EastLink

ENVIRONMENT PROTECTION ACT 1970
RESPONSE TO SECTION 22
NOTICE TO SUPPLY FURTHER INFORMATION

ATTACHMENT “D”

Figure D4 – Offtake from Wastewater Sump to Tanker

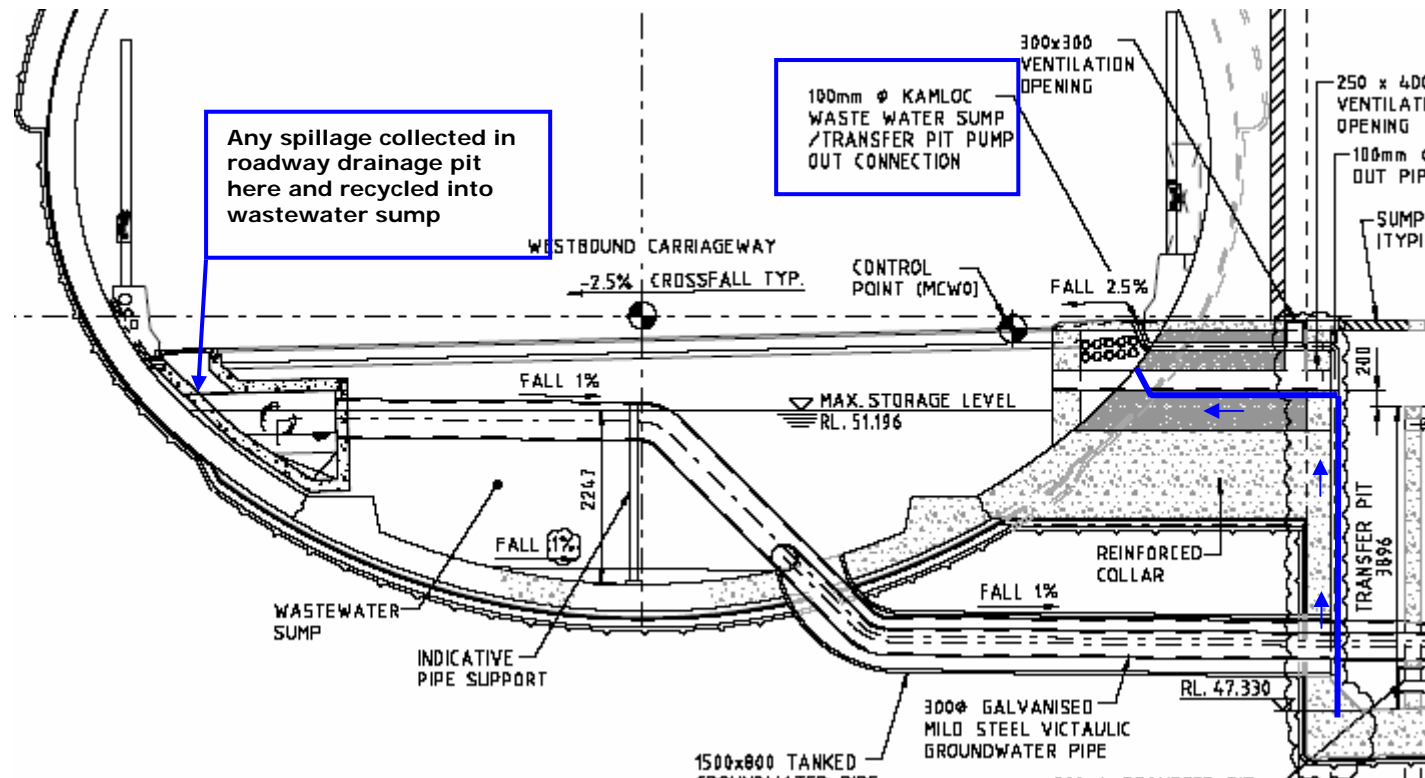
D4: Provide preliminary design level drawings of the off-take point to tanker. Inclusive in the design drawing will be the location of the off-take point and spill protection provisions (bunded area and capacity, drainage management).

A kamloc fitting on the offtake from the wastewater sump has been provided to ensure that spillage cannot occur between the wastewater sump and the tanker. Figure D4 below shows this arrangement. The applicable design report is provided in Appendix 4 to this Section 22 Notice response.

In the unlikely event that a spill does occur, the pump-out area is bunded in that it is located in the low point in the tunnel and any spillage will recycle back into the tunnel pump sump via the surface-water drainage system (ie across the pavement).

Figure D5 – Pumpstation layout showing pumps

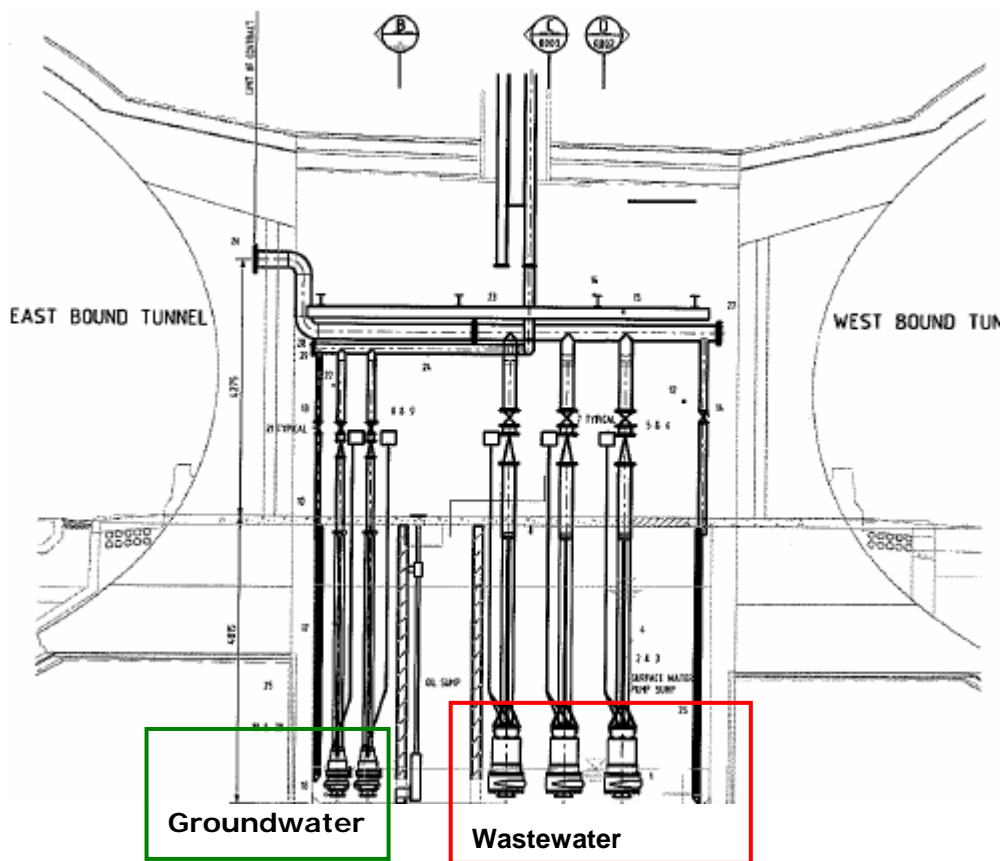
D5: Provide a description of the redundancy in the groundwater off-take system to sewer and wastewater pump out system.

Redundancy in the off-take system to sewer is supplied by two service pumps notionally of 6-8 litres/second capacity each (one duty, one standby, only one litre/second required).

Redundancy in the surface water system to wetland is supplied by three service pumps notionally of 75 litres/second capacity (two duty, one standby).

Redundancy in the wastewater system is provided through removal by tanker from the wastewater sump in the event that the pump system is not available. Wastewater can also be pumped out from the overflow weir in the pump station or alternatively through access pits in the roadway.

A spare 250mm pipe is provided within the riser for the operator to use in the event of rising main failure or other issues requiring temporary removal of a rising main from service. This provides redundancy for both surface water and groundwater systems.

Chart D6 – Sensitivity of low flow regime to increased extraction from Mullum Mullum Creek

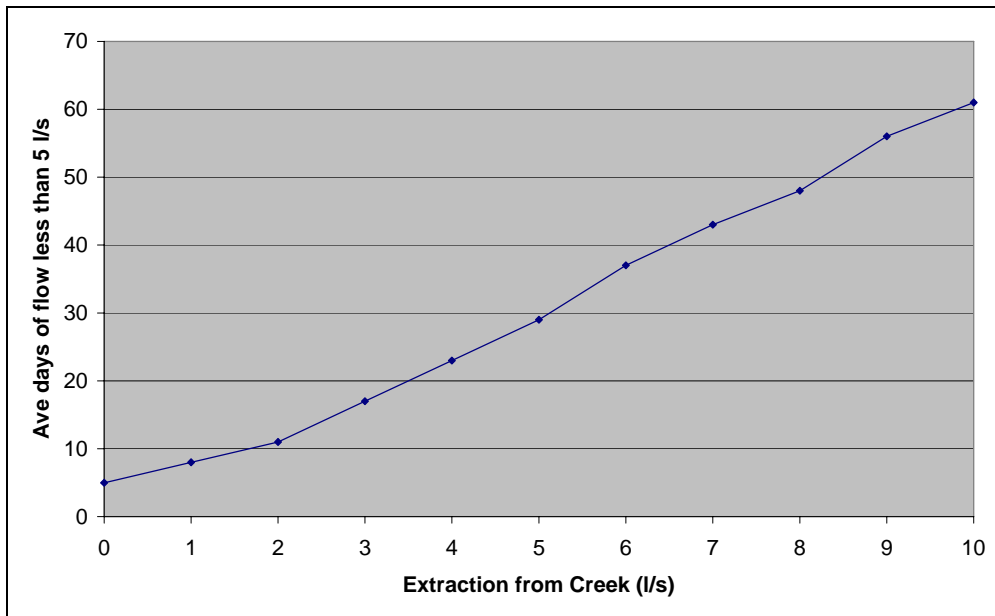
D6: Provide an impact assessment (assuming 1 L/s) and associated sensitivity analysis (inflow volumes exceed 1 L/s) of drawdown in groundwater associated with the discharge to the operating tunnel on the flows in the Mullum Mullum Creek. Include a discussion of the basis for selection of the sensitivity flow values and any impacts on monitoring or management that higher inflows may cause.

Review of existing data indicates that given the variability of the flows in Mullum Mullum Creek, on average the flow drops below 5 l/s for 5 days per year. (In the entire recording period, the flow has fallen below 5 l/s in 5 years, ie once every 5 years on average, and this has occurred for a total of 121 days in the 25 year record). If an additional 1 l/s was taken out of Mullum Mullum Creek the number of days that flow drops below 5 l/s could be expected to increase to 8 days per year. If only an additional 0.5 l/s is taken out of Mullum Mullum Creek, flows drop below 5 l/s on average 6 to 7 days per year.

Chart D6 below shows that the relationship between loss of water from Mullum Mullum Creek and number of days (on average) flow is less than 5 l/s is approximately linear up to 10 l/s extraction.

As stated earlier, only a small part of any groundwater inflow into the tunnel is likely to come from the creek or the groundwater which contributes to creek flows. It could be expected for an additional 1 l/s reduction in creek flow, the tunnel groundwater inflow would have to increase to greater than 3 l/s.
